JOSEPH WHITE SUBDIVISION

APPLICATION NUMBER 21 DATE November 15, 2007

DETAIL SITE PLAN

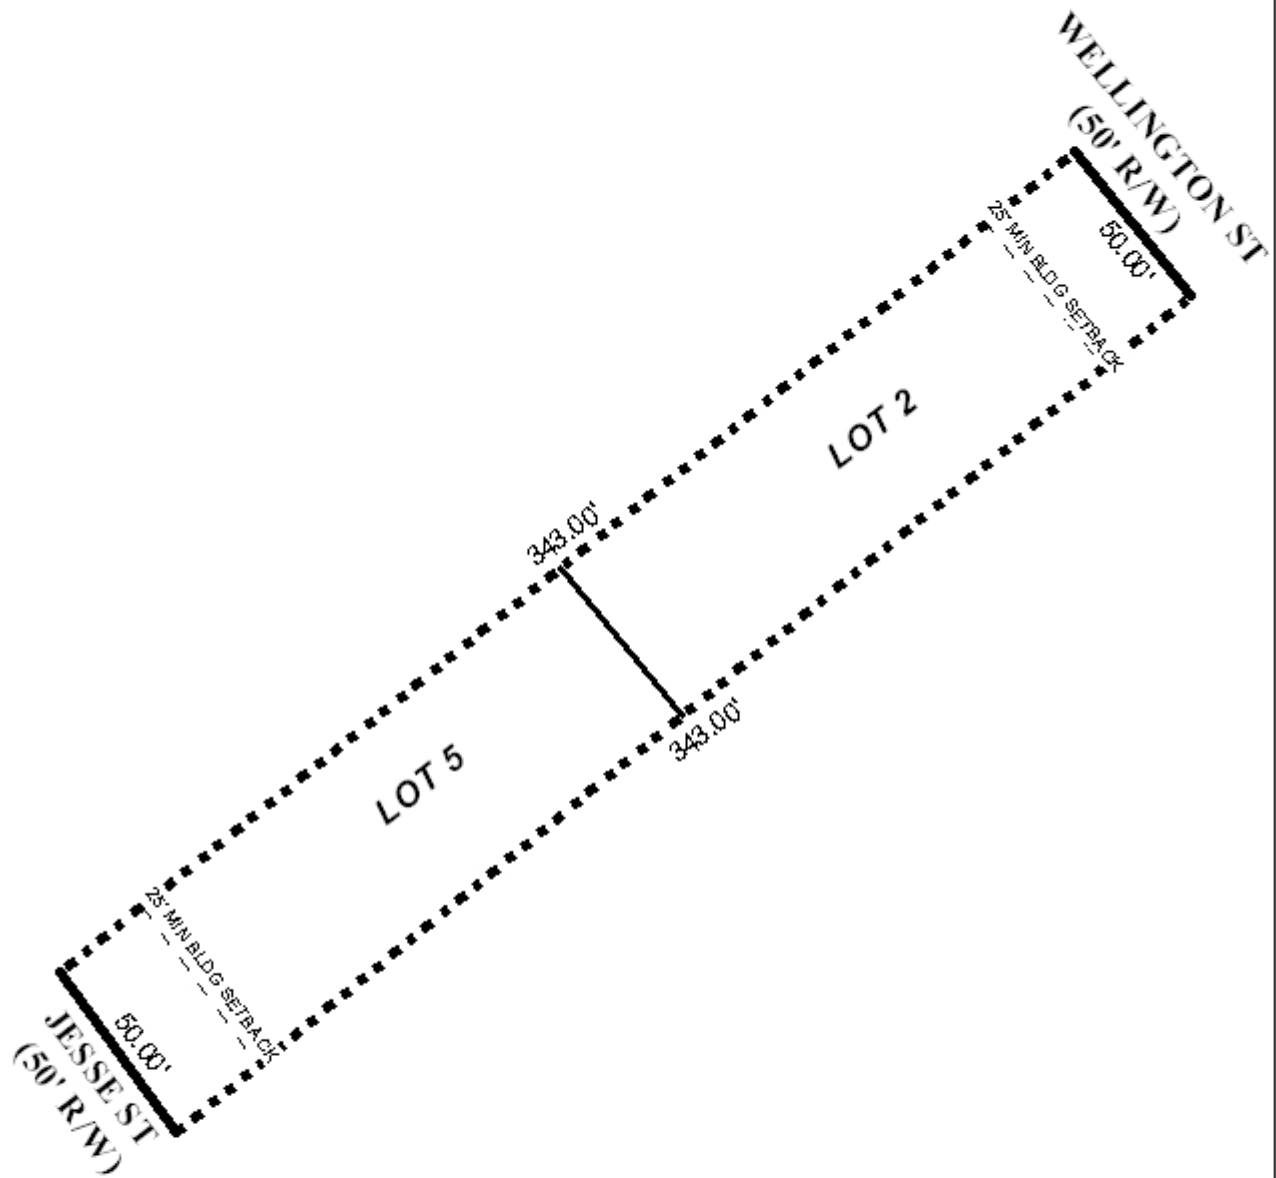
The site has frontage on both Wellington Street and Jessie Street, with adequate rights-of-way of 50' each. A 25' minimum building setback line along both street frontages is illustrated on the plat, and should also be illustrated on the final plat. A note should be placed on the final plat limiting each lot to one curb cut, with the size, location, and design to be approved by Traffic Engineering and conform to AASHTO standards.

Both lots are 50' wide and predate the current Subdivision Regulations; therefore, a waiver of Section V.D.2. of the Subdivision Regulations would be required. The proposed lots would each contain 0.2± acres and would be compliant with the minimum lot size requirements of the Subdivision Regulations. The plat labeled the lot sizes in acreage, but should be revised to indicate the lot sizes in square feet on the final plat, or a table should be provided furnishing the same information. The lots meet the depth-to-width ratio of the Subdivision Regulations.

1. the depiction of the 25' minimum building setback line along Wellington Street and Jessie Street;
2. placement of a note on the final plat stating that each lot is limited to one curb cut, with the size, location, and design to be approved by Traffic Engineering and conform to AASHTO standards;

3. labeling of each lot with its size in square feet, or the provision of a table on the plat depicting the same information;
4. subject to the Engineering Comments *(It is the responsibility of the applicant to look up the site in the City of Mobile (COM) GIS system and verify if NWI wetlands are depicted on the site. If the COM GIS shows wetlands on the site, it is the responsibility of the applicant to confirm or deny the existence of wetlands on-site. If wetlands are present, they should be depicted on plans and/or plat, and no work/disturbance can be performed without a permit from the Corps of Engineers. Must comply with all storm water and flood control ordinances. Any work performed in the right of way will require a right of way permit.); and*
